# Implementing improved extinction ratio limit

- To allow a variety of transmitter technologies for good performance, low power and cost, the extinction ratio spec should be reduced to as low as reasonable while protecting the link and the receiver
  - As shown in recent presentations in P802.3cd ad hoc and P802.3bs SMF ad hoc
- [http://ieee802.org/3/bs/public/adhoc/smf/17\\_04\\_25/dawe\\_01\\_0417\\_smf.pdf](http://ieee802.org/3/bs/public/adhoc/smf/17_04_25/dawe_01_0417_smf.pdf)
- [http://ieee802.org/3/cd/public/adhoc/archive/dawe\\_042617\\_3cd\\_adhoc-v3.pdf](http://ieee802.org/3/cd/public/adhoc/archive/dawe_042617_3cd_adhoc-v3.pdf)
- This presentation shows two simple ways to do this for 100GBASE-DR

# Transmitter setup map: proposal A

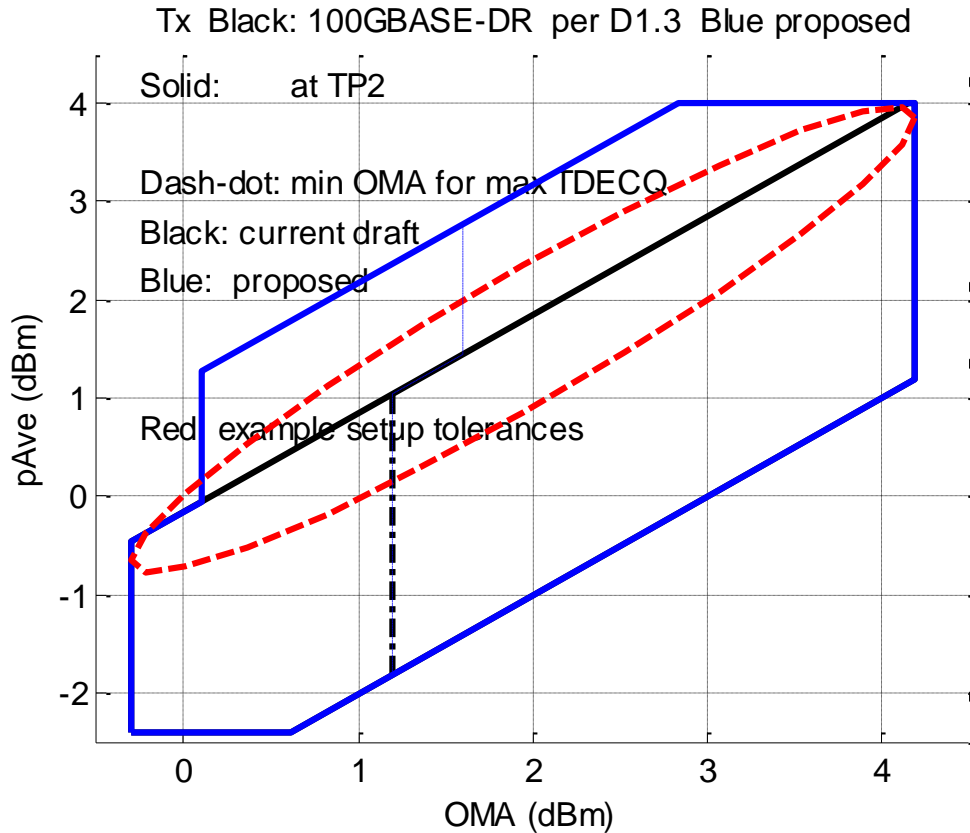
- Black polygon (partly hidden under blue one): Tx spec in D1.3, with 5 dB min. extinction ratio
- Blue polygon: proposal A
- OMA-TDECQ is increased by 0.4 dB between 3.5 and 5 dB extinction ratio, to allow for multipath interference penalty of the reflections in the draft
- Tx spec is easier
  - Needs very good power control (output coupling, tracking, ageing)
- Channel, connectors and receivers don't change
  - Unless we change the SRS ER: see slide 9

# Transmitter setup map: proposal B

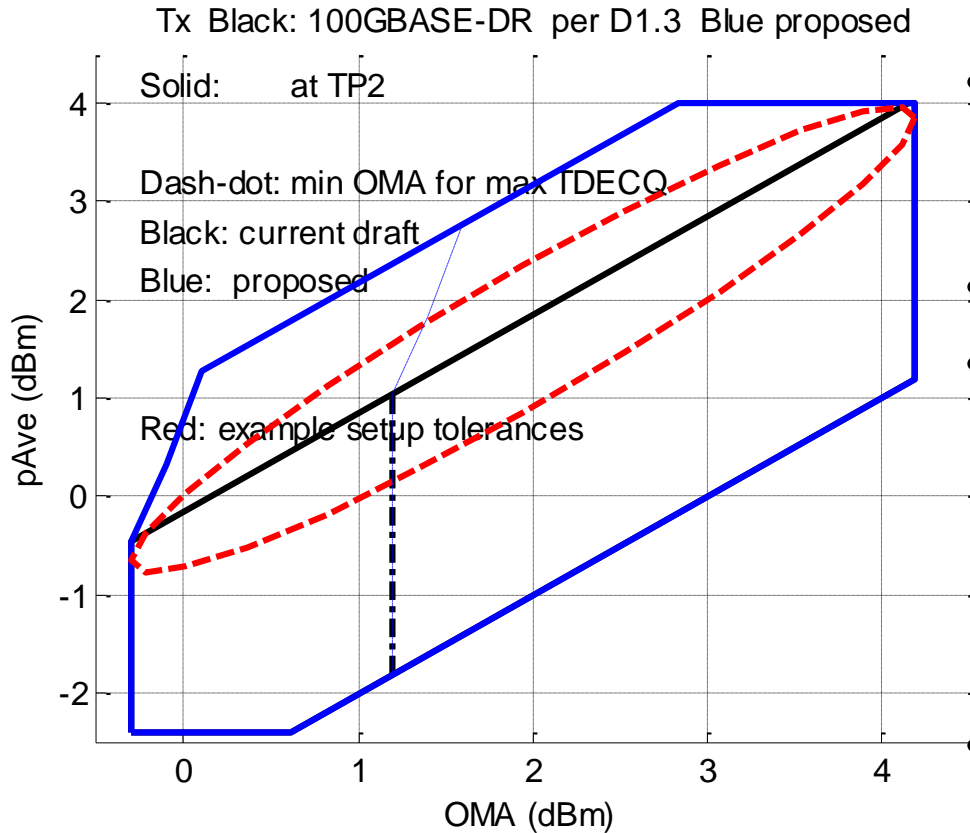
- Black polygon (partly hidden under blue one): Tx spec in D1.3, with 5 dB min. extinction ratio
- Blue polygon: proposal B
- OMA-TDECQ is increased by 0.4 dB at 3.5 dB extinction ratio, to allow for multipath interference penalty of the reflections in the draft
  - Gradual increase with extinction ratio avoids re-entrant corner
- Tx spec is easier
  - Power control requirements are more reasonable
- Channel, connectors and receivers don't change
  - Unless we change the SRS ER: see slide

# Both options

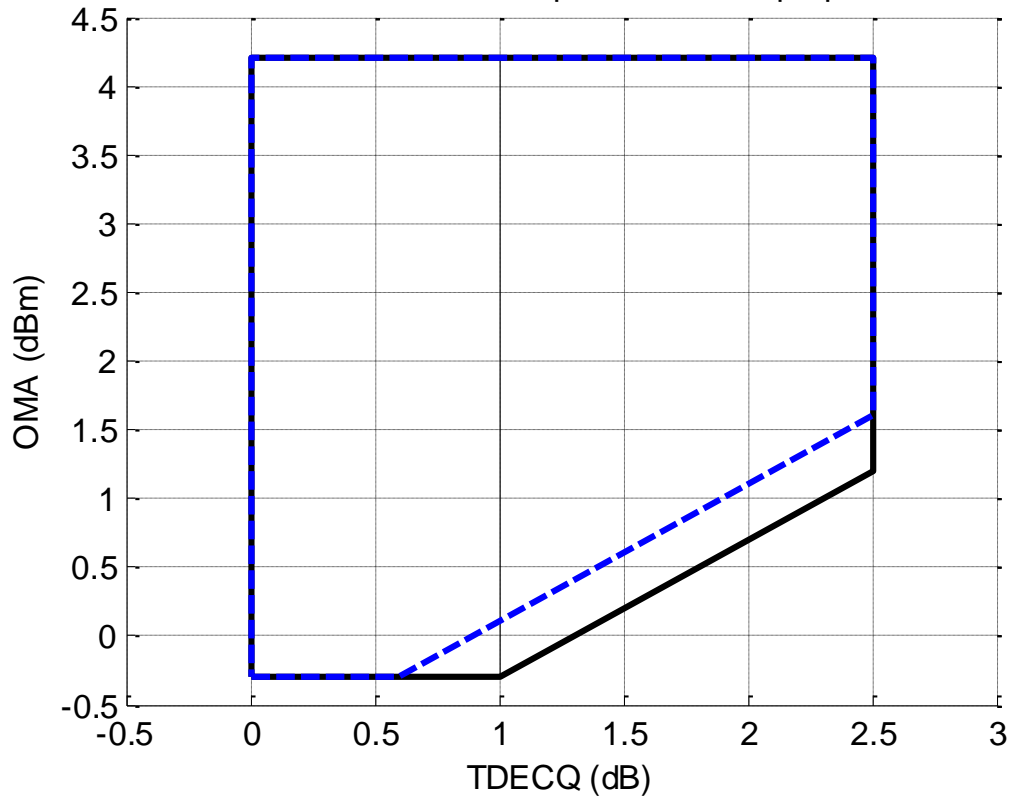
- **140.7.9 Stressed receiver sensitivity**
- Add another exception:
- The extinction ratio is to be approximately 5 dB
- *Explanation: the drafts say:*
- Stressed receiver sensitivity shall be within the limits given in Table 140–7 if measured using the method defined in 121.8.9 with the following exceptions
  - and
- **121.8.9.2 Stressed receiver conformance test signal characteristics and calibration**
- ... set the extinction ratio of the E/O converter to approximately the minimum specified in Table 121–6.
  - *and*
- the extinction ratio is approximately the minimum specified in Table 121–6

# Options A and B at Rx (TP3)

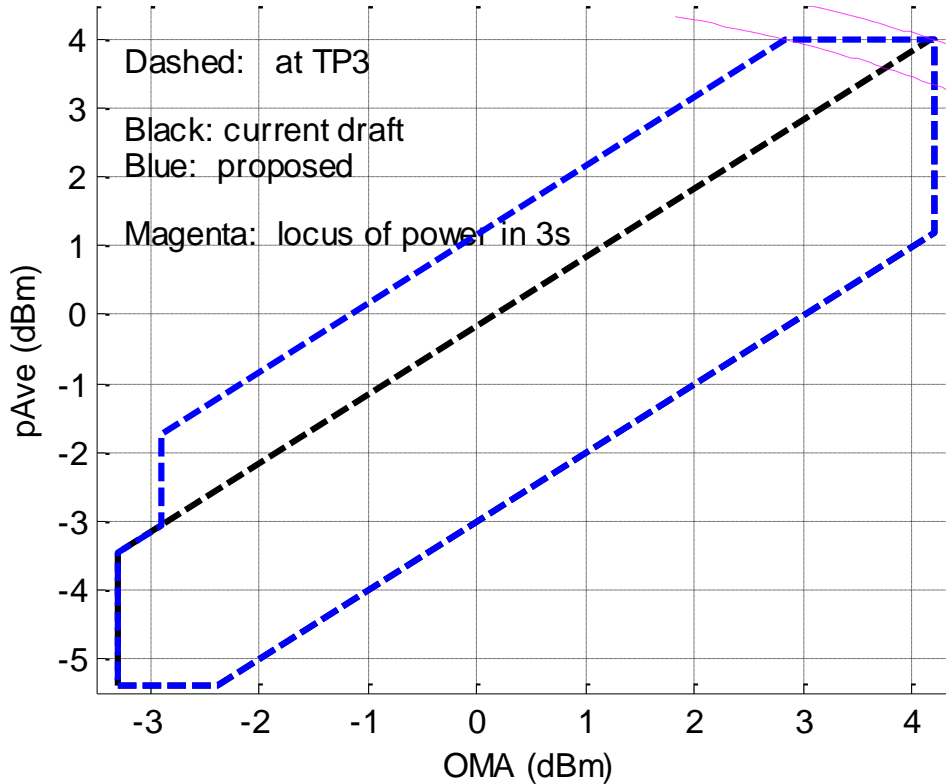
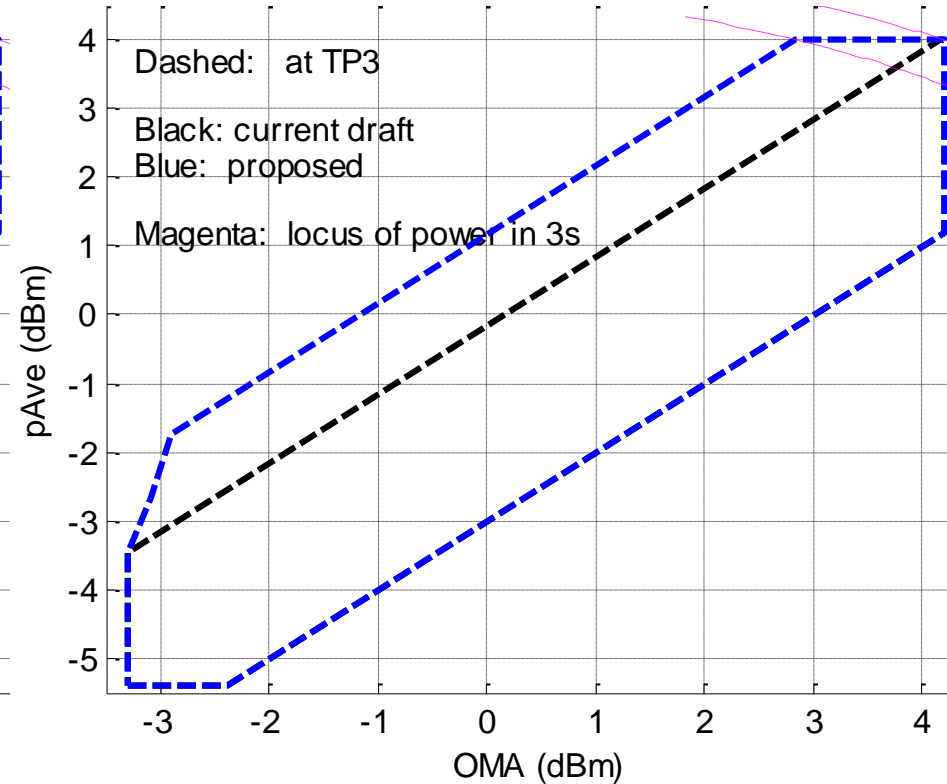
- Magenta lines show loci of equal power in runs of 3s
- Receiver overload is not affected
- Receiver sensitivity is not affected
